Carondelet Division

Corrective Action 1538
Carondelet Division
Corrective Action Type NCR
Date 1-13-06 Revised 2-28-06
CA Originator C. Ruud
Applies to: B-1 Coil

Description of Defect / Non-Conformance

Scan performed by 3D Scanco indicated that the coil deviates from the model in some areas.

Area 1:

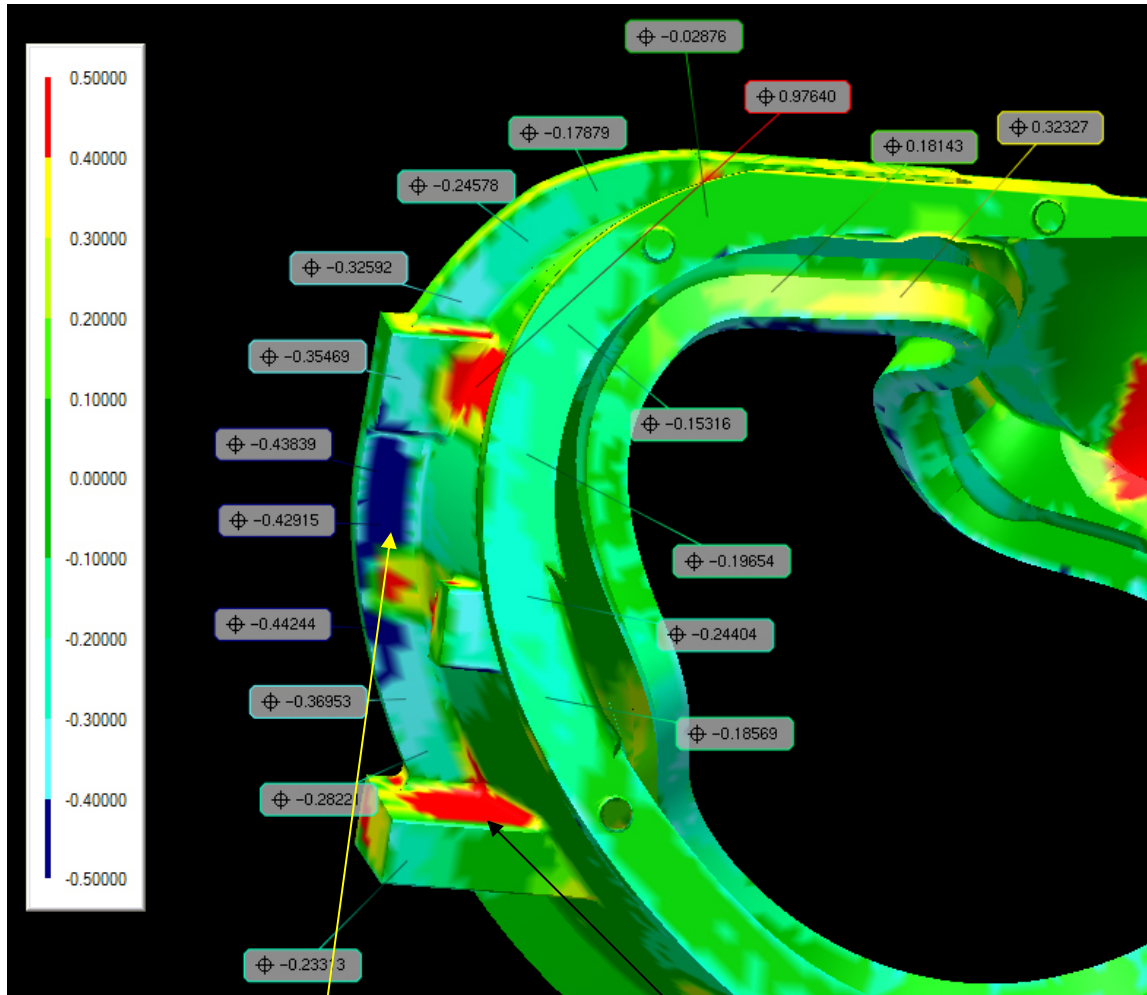
An area on the back-side of the cope flange is showing a surface profile approximately 7/16" below expected. This area will be addressed for Coil B-2 by adding approximately 7/16" stock into this area in corebox #9. On B-1 we will build up this area by welding. The opposite side will require additional machining to remove the excess.

The red area on the side of the ear is not a riser pad or any other expected condition. This will need to be further analyzed with our scan

Area 2:

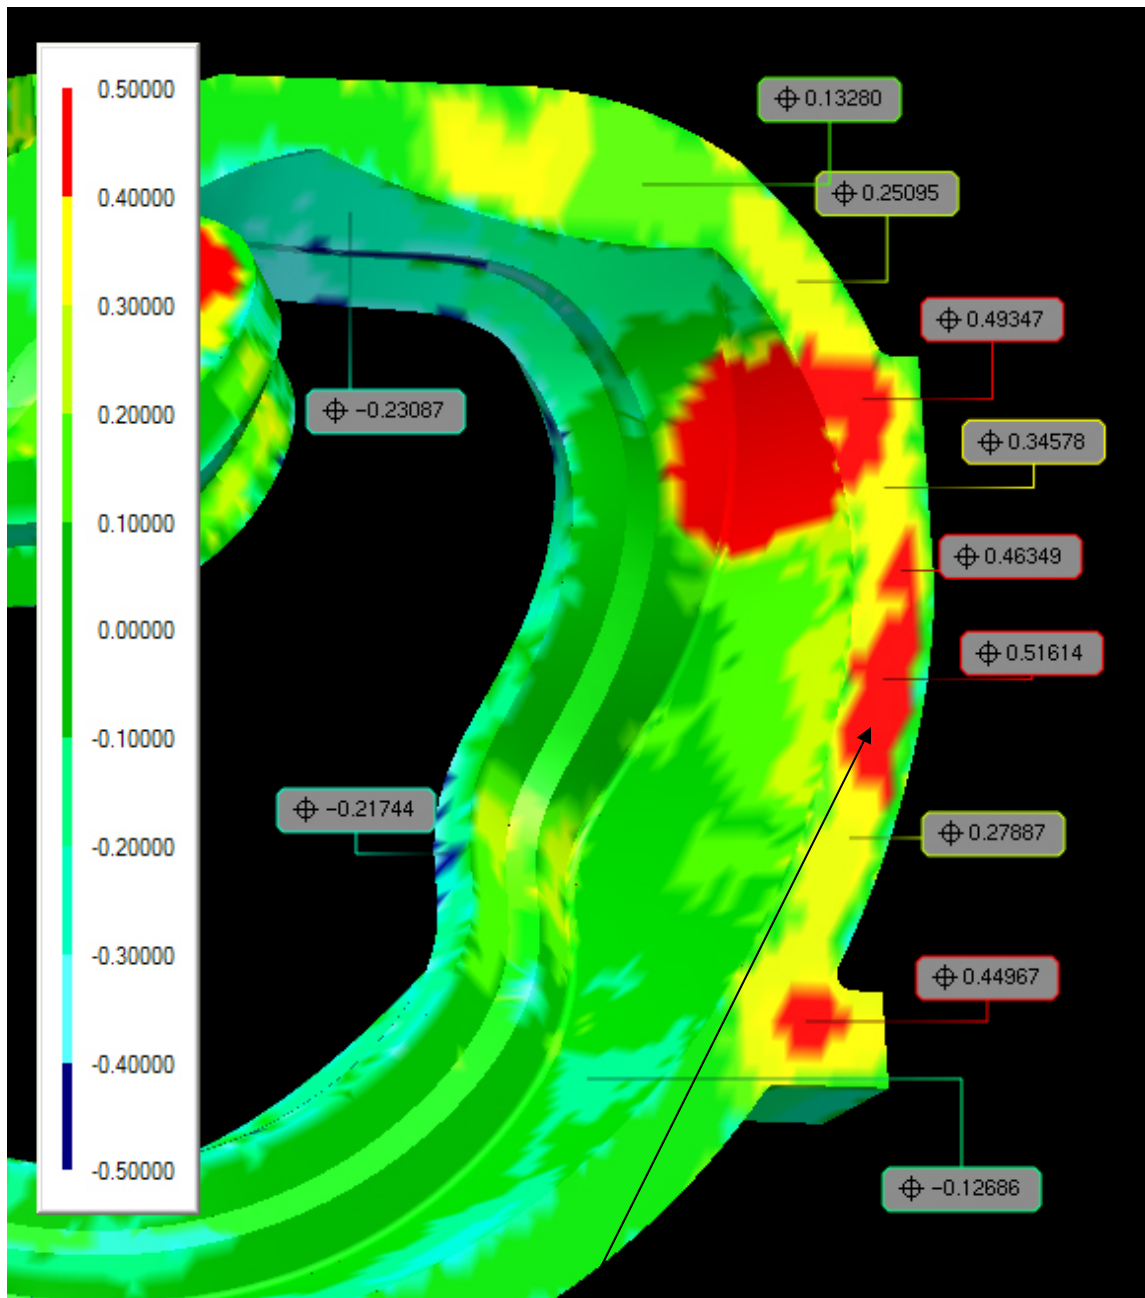
This area is on the opposite side of the flange of Area 1, but cannot be immediately related to Area 1. A riser sits directly over this spot and the excess stock could be a result of the riser contact not being cut down flush to the flange. At this point, as planned, all of the riser contact areas show the same excess stock condition. They will be worked down closer to the intended flange surface later in the process.

Area 3:

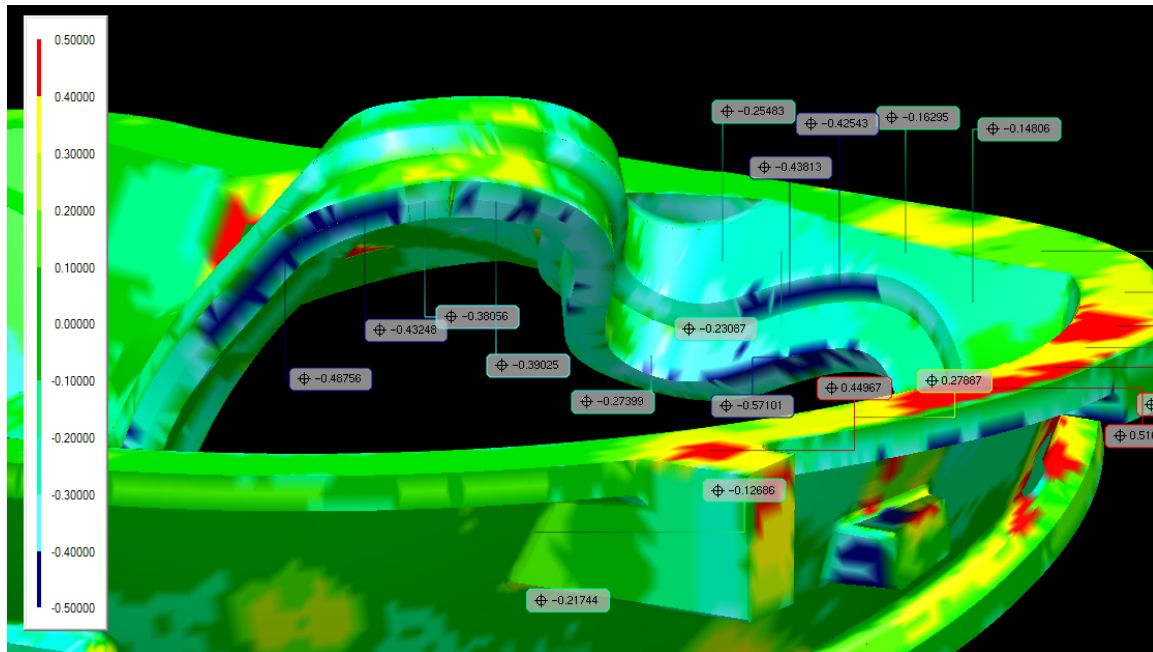
There are a few areas around the race track that display a loss of machine stock anywhere from 3/8" to 9/16". There was 1" machine stock planned in this area, so stock still remains, but the tooling will be inspected for flaws and repaired as needed.

Area 4: (see page 8 of the Scanco report)

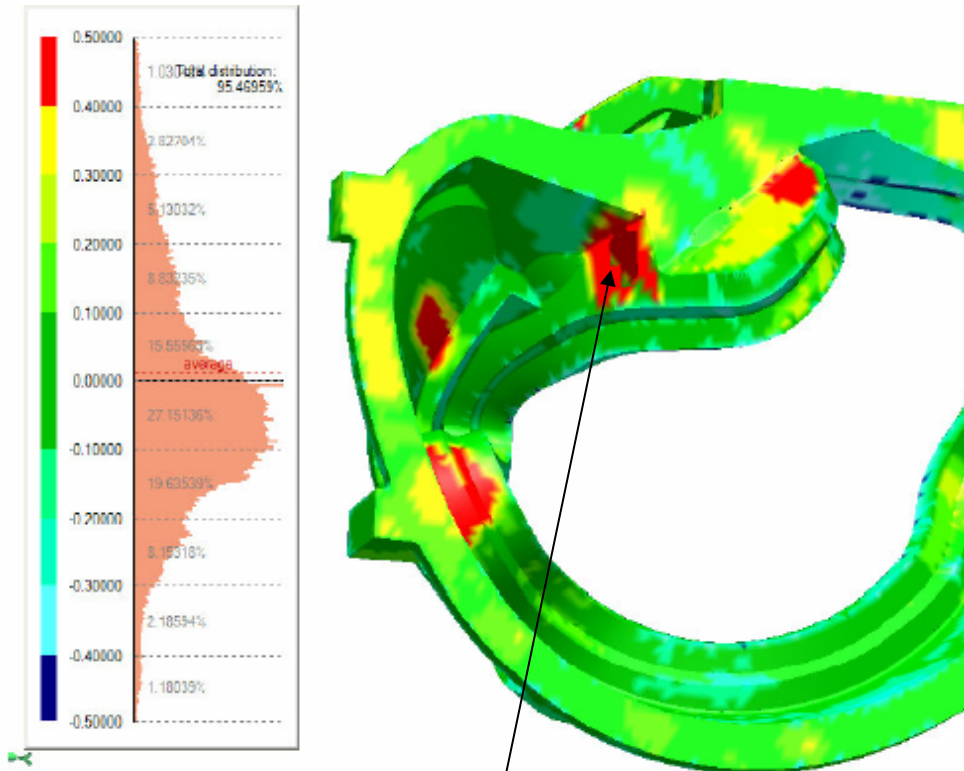
Overall wall thickness shows a condition very similar to the A coils we have processed. Scanco's analysis shows wall thicknesses in the range of 1.21" to 1.54" which is what we would have expected based on Coil A results. No action is planned for this condition. We recommend use as is.

Area 5:

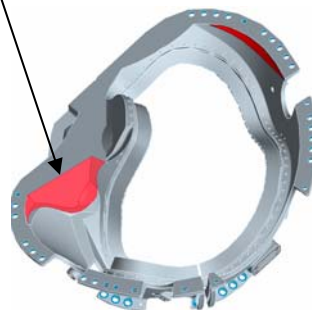
This wing area interface contains a riser pad that will require removal. The rest of the interface seems to be within a +/- 0.2" profile, but due to the color scheme used I cannot tell if it tends toward the plus or minus side of that tolerance. Our layout scan will be clearer in this regard.

Area 6:

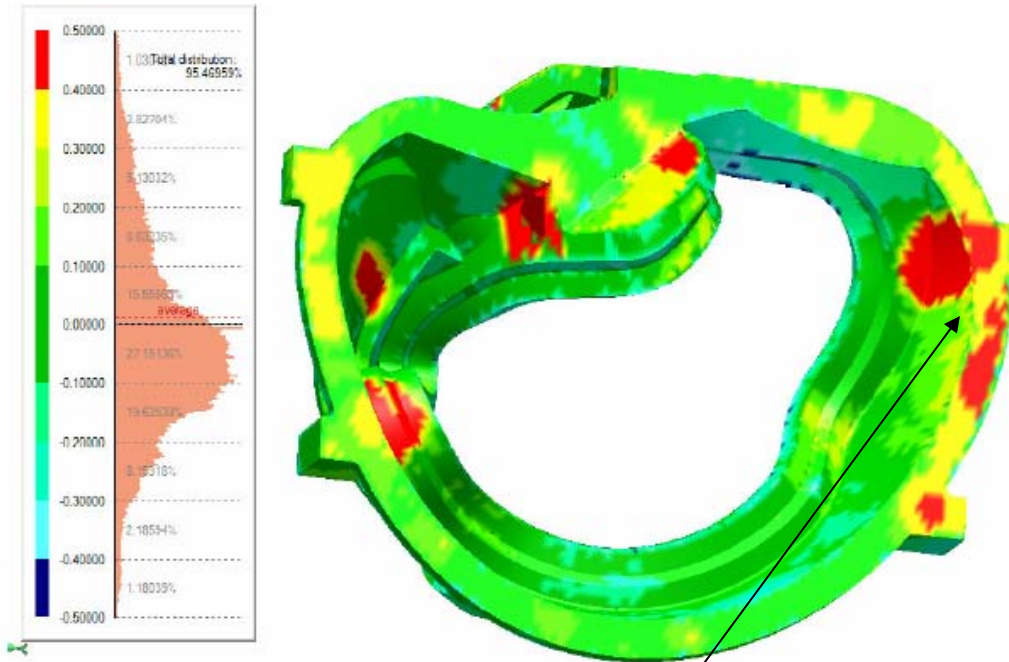
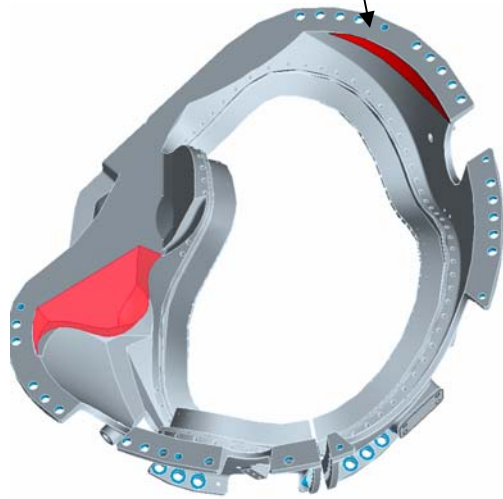
The narrow wing interface here is partially covered by a riser contact that will require removal. The balance of the area is 0.2-0.4" above the intended profile and will require material to be removed.

Area 7:

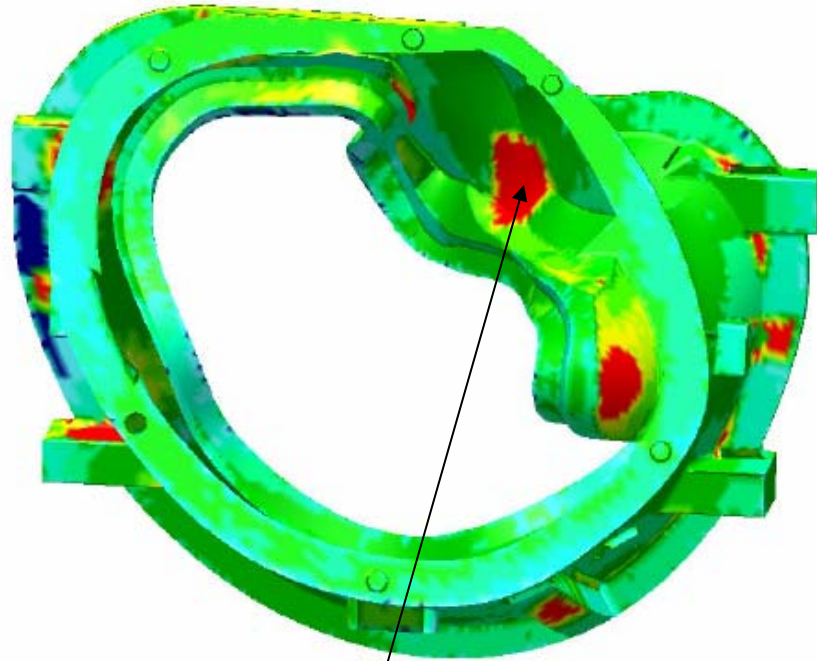
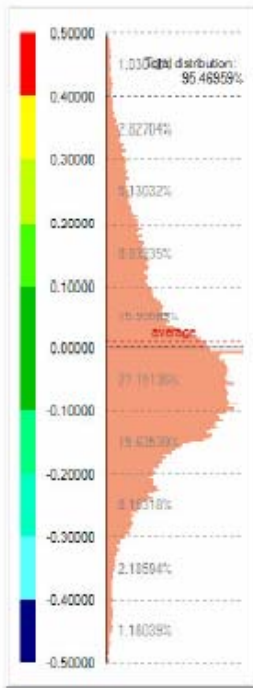
This wing area interface contains a riser pad that will require removal. The balance of the area is contained within the +/- 0.2" tolerance band, but once again due to the color scheme, I am not able to discern which side of the tolerance the part tends toward. Our scan will show this clearly.
